STATE OF WASHINGTON
DEPARTMENT OF ECOLOGY

Re: Opinion pursuant to WAC 173-340-515(5) on Proposed Remedial Action for the following Hazardous Waste Site:

- **Site Name:** Cowman Campbell Paints
- **Site Address:** 5221 Ballard Avenue NW, Seattle, WA
- **Facility/Site No.:** 30774595
- **VCP Project No.:** NW3030
- **Cleanup Site ID No.:** 8651

Monitoring Well Location Plan
5221 Ballard Ave NW
Seattle, Washington

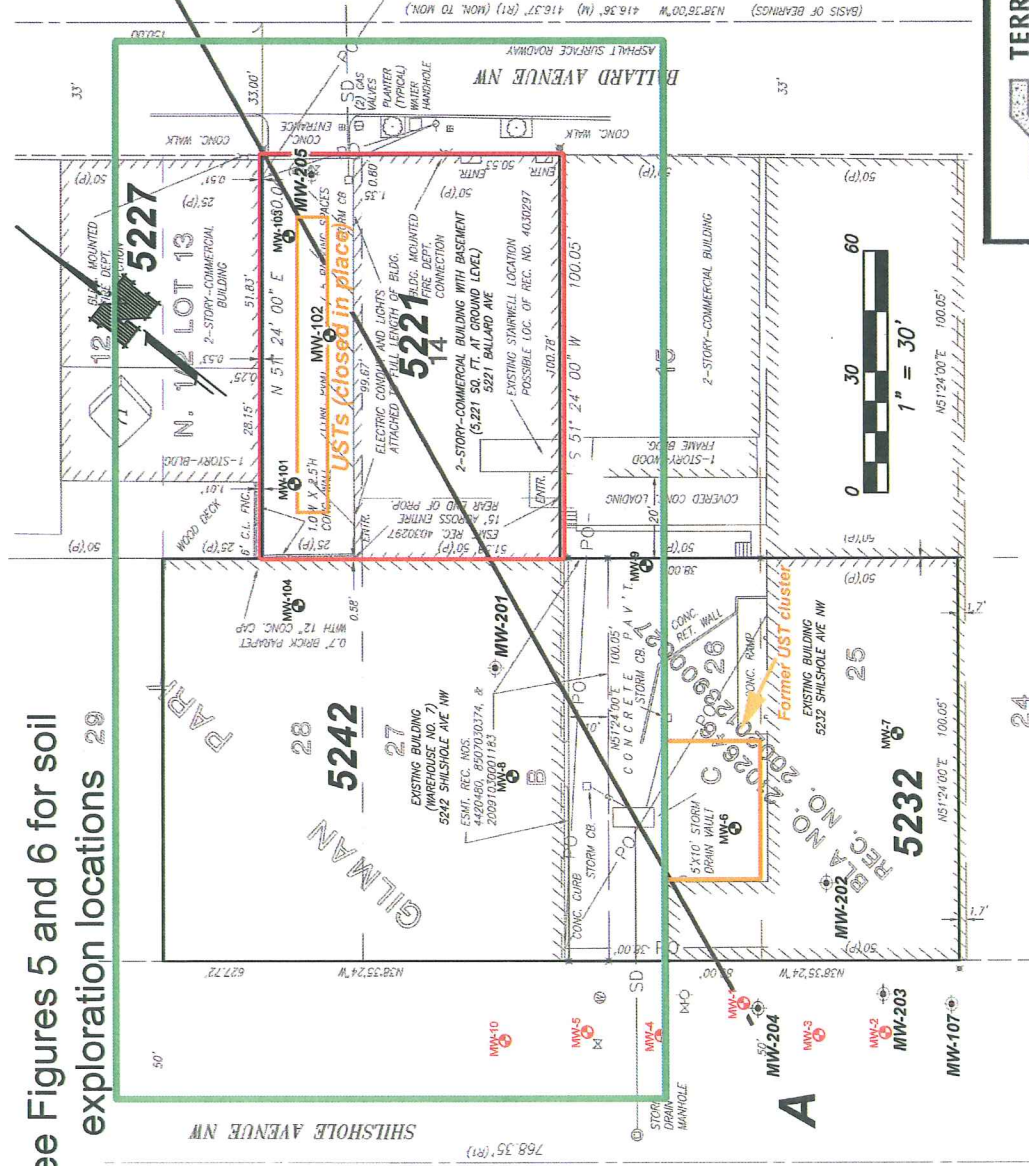
- Please include ground water elevation data from all wells including MW-6 in the ground water elevation contour diagrams. If the ground water elevation at MW-6 is consistently anomalous, the reason needs to be determined rather than eliminating the data point.

- Ecology recommends installation of at least one additional monitoring well on the Property that would replace MW-101 and MW-102 and also be downgradient (and north of) the USTs that are closed in place in addition to MW-205.

Proj. No. T-6552 Date Oct 2015 Figure 6

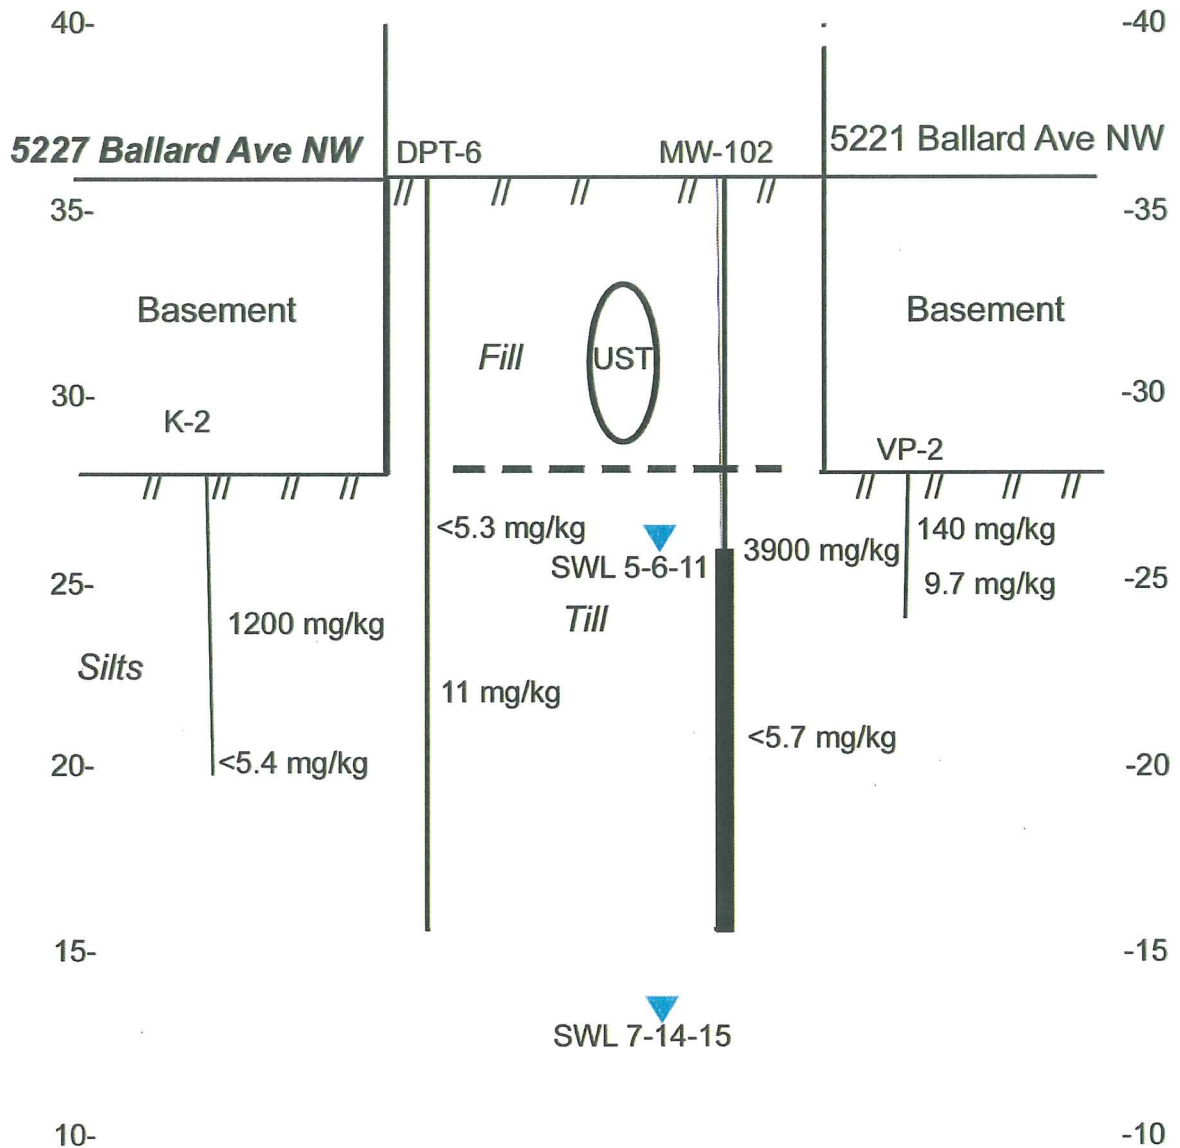
- In Table 5.2.2 of the same report, please use micrograms per liter as the units.
- In Figures 5 and 6 of the Supplemental Site Sampling and Discussion report, please add concentrations used to draw the boundary of "Approximate limit of release impacts to soil from 5221".
